**Comment Set A1 – Bureau of Land Management****United States Department of the Interior****BUREAU OF LAND MANAGEMENT**

*BLM Hollister Field Office Annotated Comments on the Draft Supplemental EIR for Panoche Valley Solar Project (6 pp.)*

Subject: **Panoche Valley Solar Project Draft Supplemental Environmental Impact Report (SCH#2010031008)**

Figure 1. Hypothetical Blunt-Nosed Leopard lizard Detection, Five-Acre Avoidance Buffer, Home Range, and Location of Lizard when Construction Commences

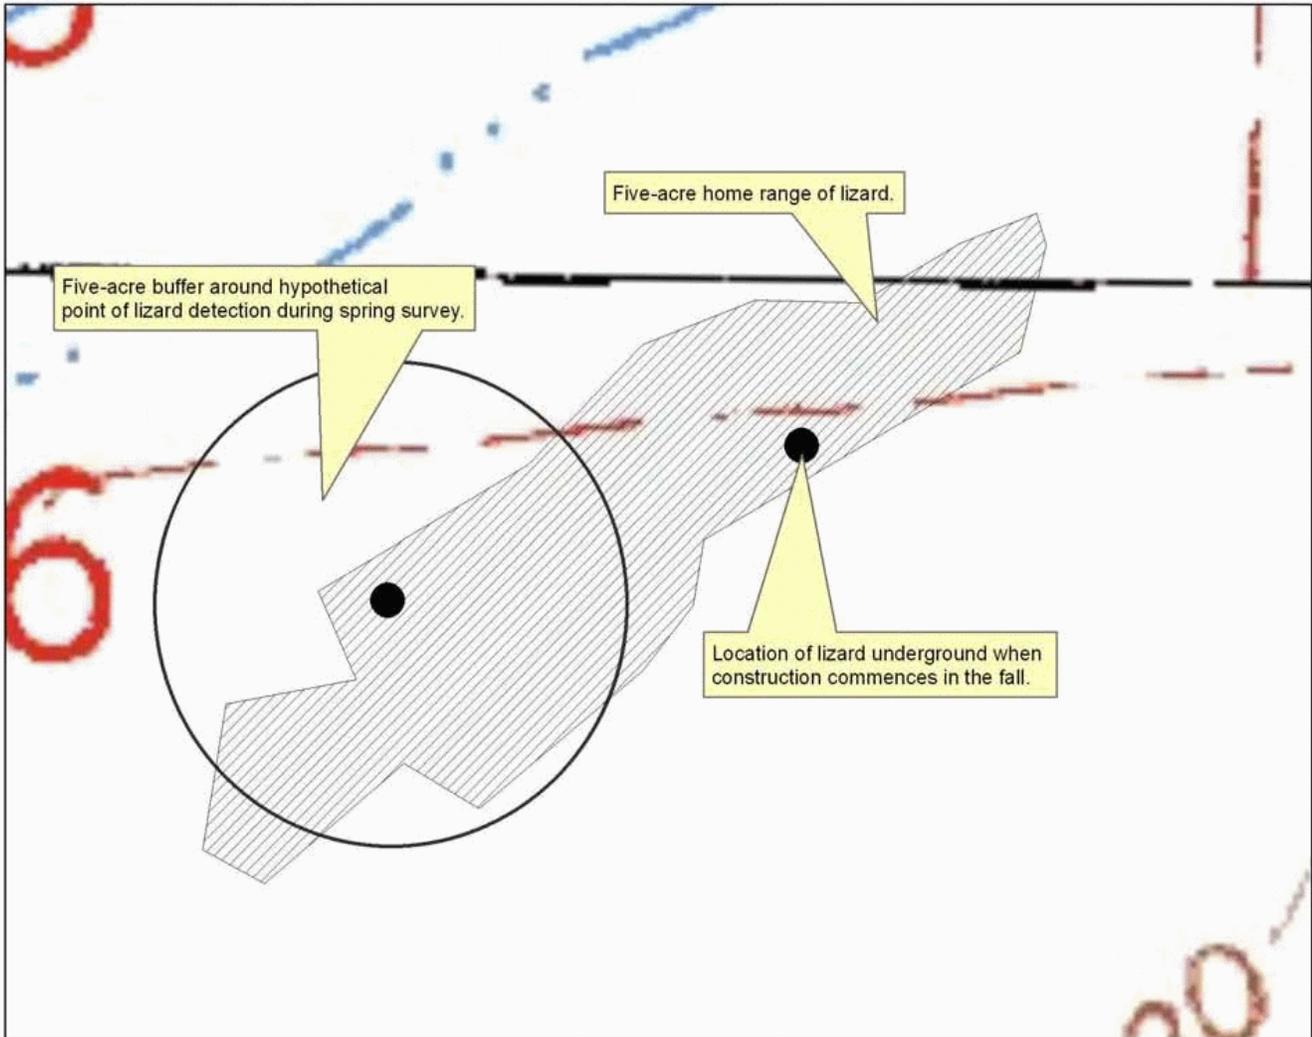
In this case, the five-acre avoidance buffer would not encompass most of the home range, and could result in “take” during construction. Predicting the actual shape of a home range where all surrounding habitat is suitable is not possible.

Figure 2. Five-acre Avoidance Buffer Relative to a 21.8-acre Buffer and Hypothetical Home Range.

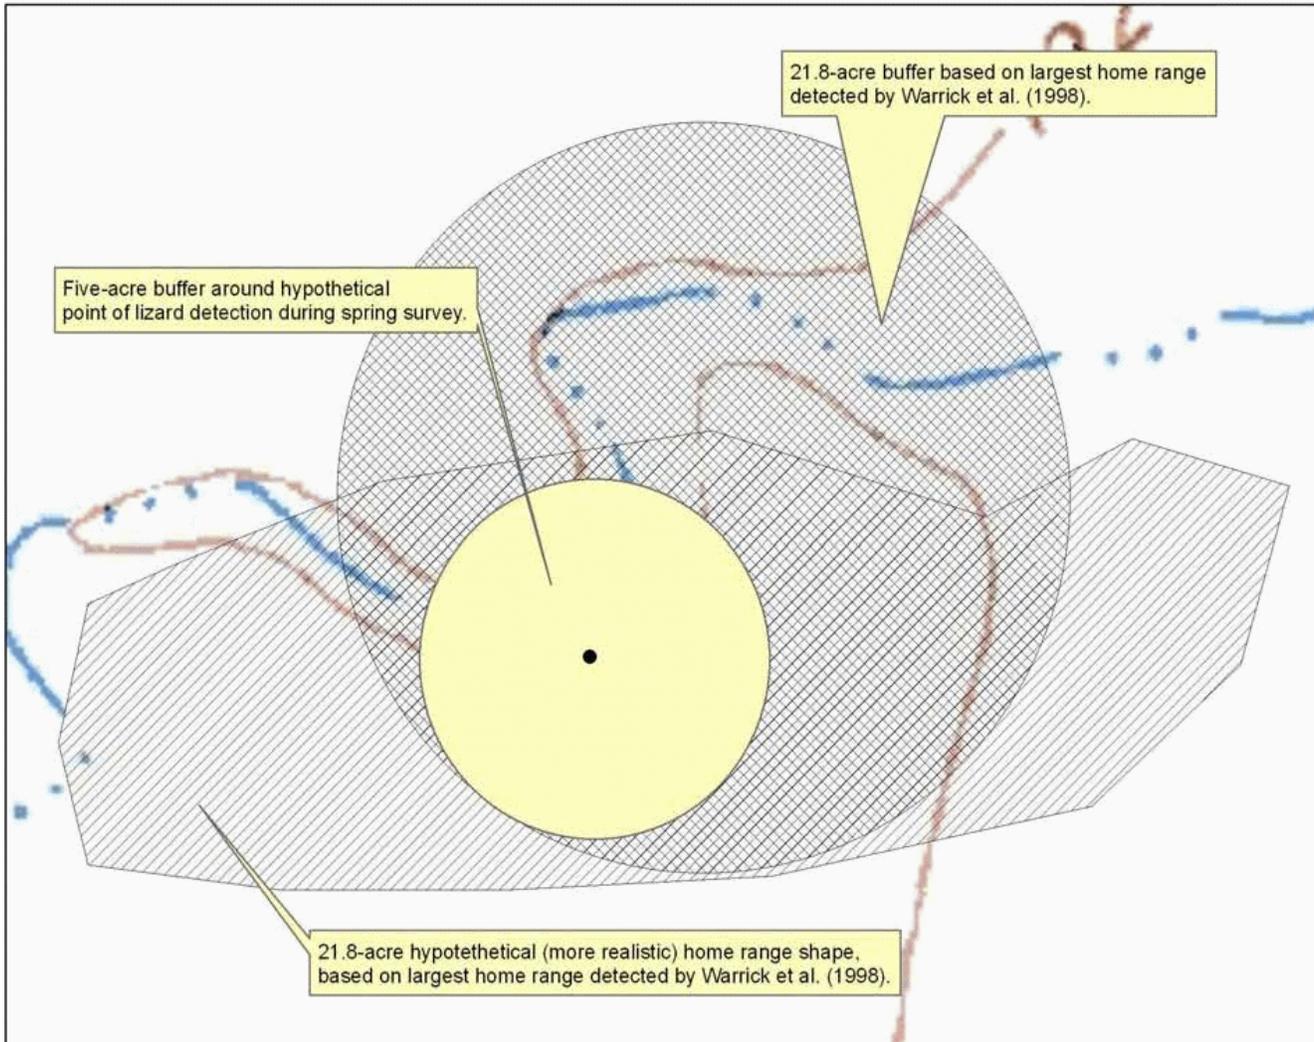
A five-acre avoidance buffer would encompass a small part of the full range of home ranges sizes described by Warrick et al (1998), which were as large as 21.8 acres. When construction ensues, the lizard is likely to be outside of the five-acre buffer area.

Figure 3. Area Required to Encompass the Range of Potential Home Ranges around a Single Lizard Observation

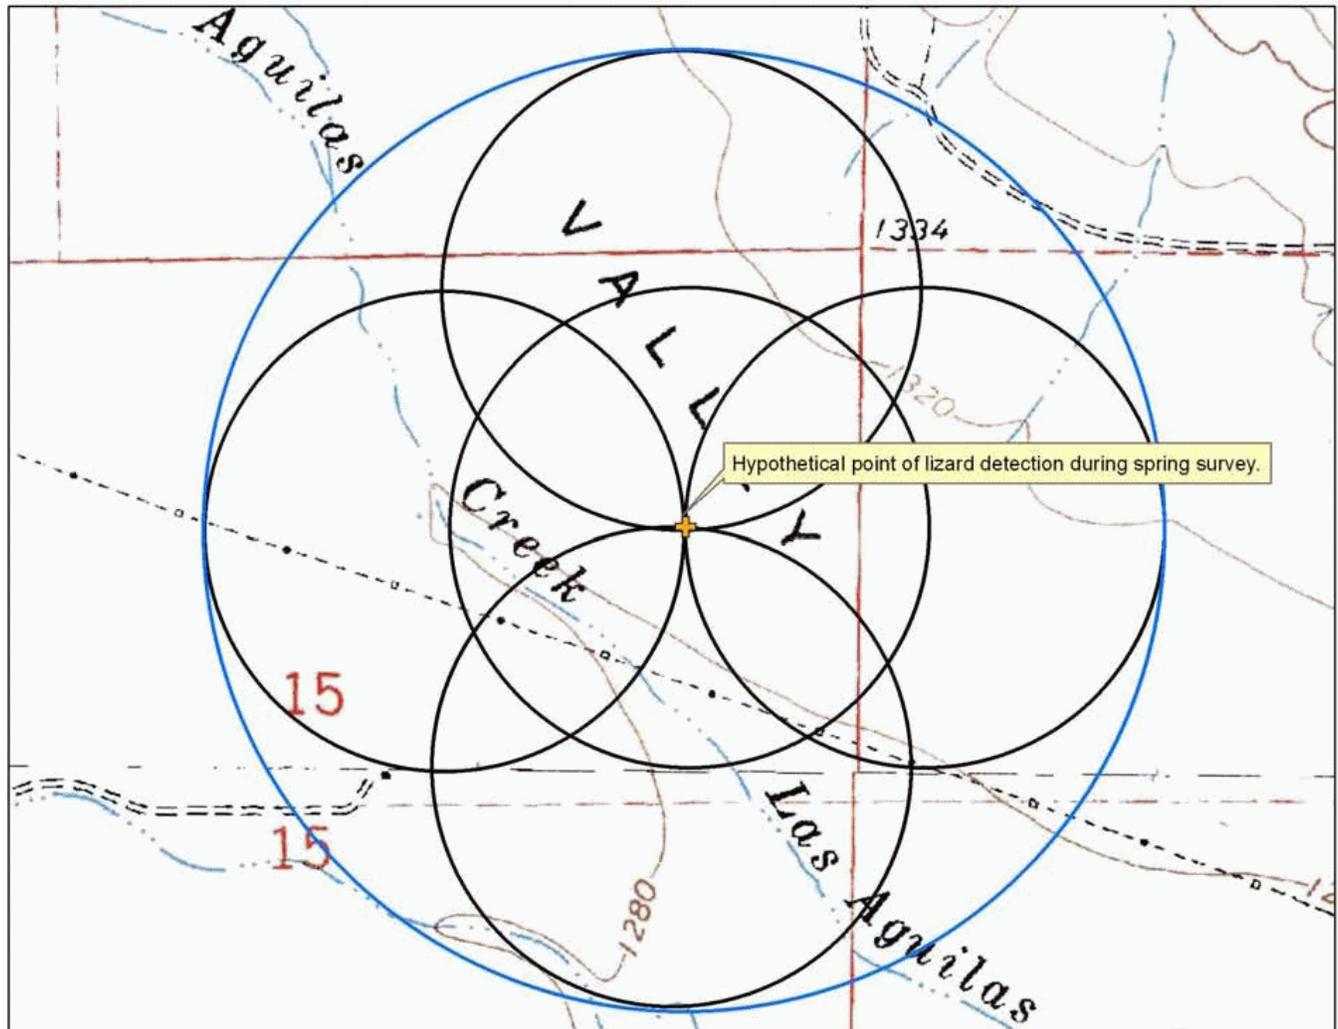
The center circle represents a uniform buffer applied around the location of a lizard observation. The other four inner circles represent four potential home ranges of equal size, assuming that the lizard was detected on the margins of its home range. The outer circle encompasses all possible home ranges in any direction from where the lizard was found. This illustrates why applying a buffer defined by an estimated home range radius (center circle) would not include most of the potential home ranges (e.g., the four other circles intersecting at the lizard detection point). Only the outermost circle encompasses the extent of possible home ranges.
